PLANNING REPORT

Planning and Zoning Commission

Thursday, June 12, 2025

All In Dublin 25-042CP

Bridge Street District Street Network Plan

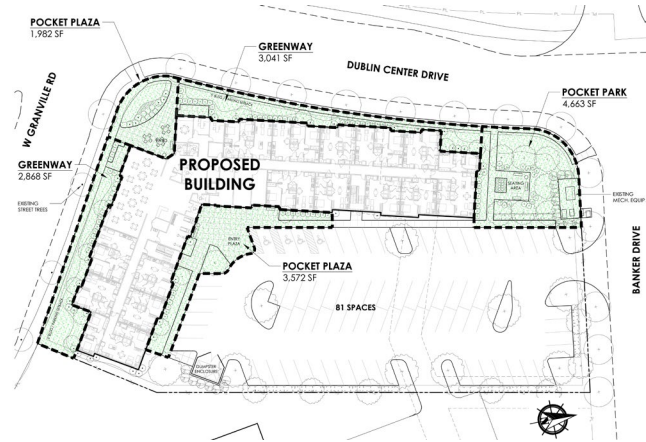
As noted above, site access is proposed via a curb cut along Banker Drive (red arrow on the map to the right) and a cross-access easement through the Fifth Third Bank parking lot (yellow arrow). Staff is not supportive of the Banker Drive curb cut given its proximity to the intersection with Dublin Center Drive. The applicant has expressed willingness to remove that access and rely solely on the one from the east. As can be seen on the map, the future north-south Neighborhood Street is envisioned to line up with the adjacent parcel's curb cuts, and gaining access through the existing Banker Drive curb cut is reasonable. However, contingencies would have to be made to preserve this access should future redevelopment of the Fifth Third Bank parcel occur, in

which case new buildings would be expected to front along Banker Drive and the new north-south street. A possible alternative solution is to provide access to the subject site through another existing easement that straddles the east property line (green arrow). This property line generally aligns with the envisioned location of a mid-block alley as reflected in the Bridge Street District Special Area Plan.
